Service Bulletin

4 - STROKE
BULLETIN NO. GS/GSX/GSX-R 175
DATE: 11/7/2007

**SAFETY RECALL CAMPAIGN #2099
ALL 2004 - 2007 GS500FK4-K7 MODELS
REAR FENDER REFLECTOR REPLACEMENT**

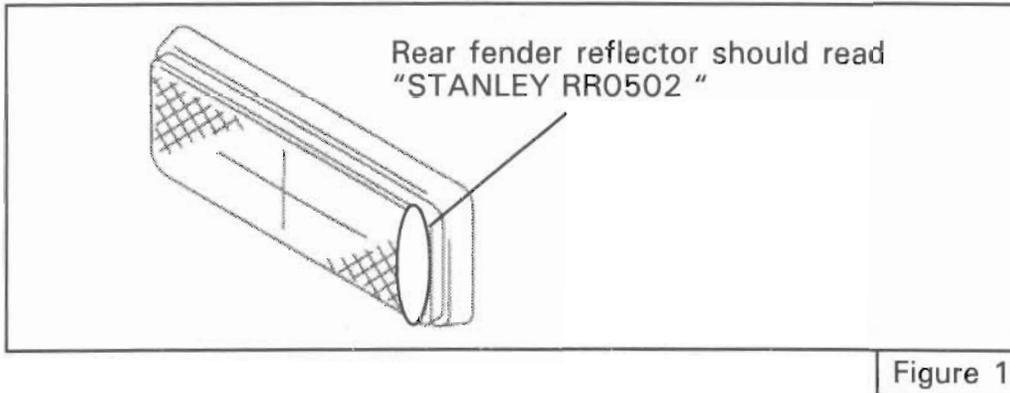
1. Check the repair status by checking the Vehicle History in the Suzuki Connect Service Menu. If the repair needs to be performed to the motorcycle, you will see the message "CAMPAIGN NOT YET PERFORMED" displayed and the rear fender reflector will need to be replaced. Refer to the replacement procedure in this bulletin.
2. Inspect the manufacturer identification markings on the rear reflector. If the name "STANLEY RR0502" is present (refer to Figure 1 on page 3) the recall repair has already been performed.

REPLACEMENT PROCEDURE:

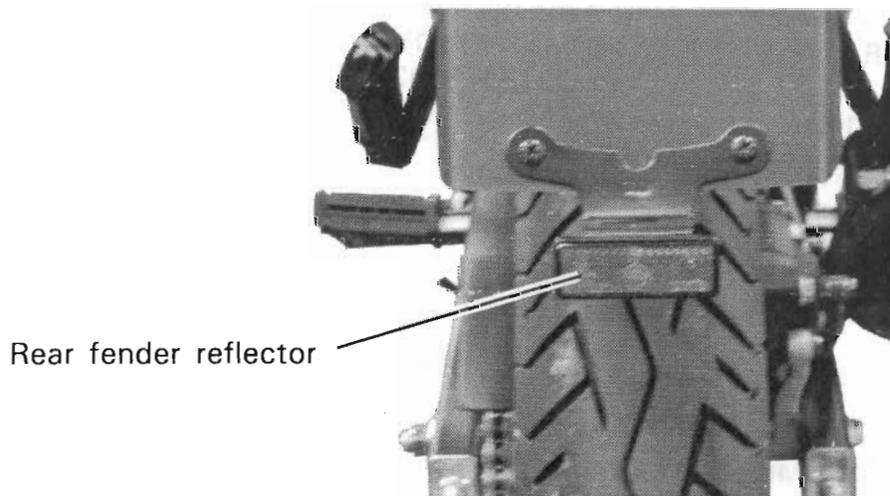
Suzuki will replace the rear fender reflector with a corrected part on all affected models.

1. Remove and replace the rear fender reflector using the preexisting nut.
